HORSHAM DISTRICT COUNCIL CONSULTATION

TO:	Horsham District Council – Planning Dept
LOCATION:	Roundstone Park Worthing Road Southwater West Sussex
DESCRIPTION:	Application for Approval of Details Reserved by Conditions 10 & 16 to approved application DC/22/0096
REFERENCE:	DISC/24/0215
RECOMMENDATION:	Advice / More Information / Modification

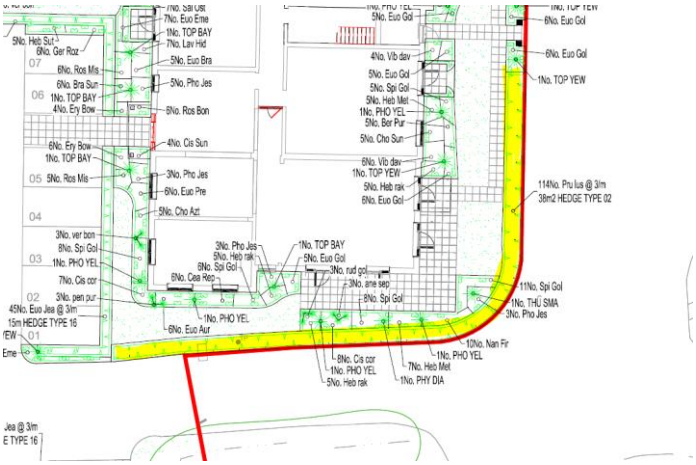
1. proposed trees are to be changed to 20-25cm girth semi-mature specimens (Acer & Tilia) along the western boundary facing the street and at the entrance of the development. Closed with thanks
2. all remaining proposed trees must be extra heavy standards (14-16cm) as a minimum girth size. Not addressed
3. Replace Pinus nigra with a more appropriate species for the residential location. Not addressed
4. It is recommended that hedge type 2 prunus lusitanica is changed to a native hedge, see mark up below – Closed with thanks
